Joint BAMx and CCSF Comments **on PG&E's December 2020 Submission of Section 3.1 Material**

The Bay Area Municipal Transmission group (BAMx)¹ and City and County of San Francisco (CCSF) appreciate the opportunity to provide comments on Pacific Gas and Electric Company's (PG&E) December 1, 2020 submission of Section 3.1 Material for the Stakeholder Transmission Asset Review (STAR) Process on PG&E's FERC-jurisdictional electric transmission projects involving capital expenditures incurred over the past four years and/or anticipated to be incurred through the next five years.

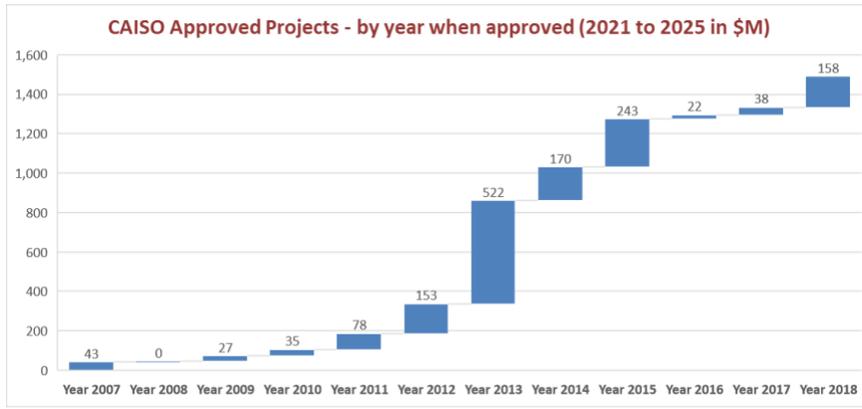
For projects approved by the CAISO, as illustrated by the bar chart above, BAMx and CCSF noticed that most of the projects (\$1.3B out of \$1.5B) were approved more than five years ago. Some of them were approved as far back as 2007 when the planning environment was vastly different from today. Are these projects still needed given the reality that the electric grid is functioning satisfactorily without them? Furthermore, BAMx and CCSF also noticed that their cost estimates have increased substantially from their original estimated amounts which could make them economically unattractive. For example, when the *Wheeler Ridge Junction* Substation project (T.0000156) was approved in the CAISO 2013-2014 TPP, it was estimated to cost between \$90 million and \$140 million.⁸ However, the December 2020 PDS identifies the Estimate at Completion (EAC) for this project to be as high as \$286 million.

BAMx and CCSF believe PG&E must immediately stop work on these previously-approved CAISO projects unless PG&E can confirm that they are still needed.
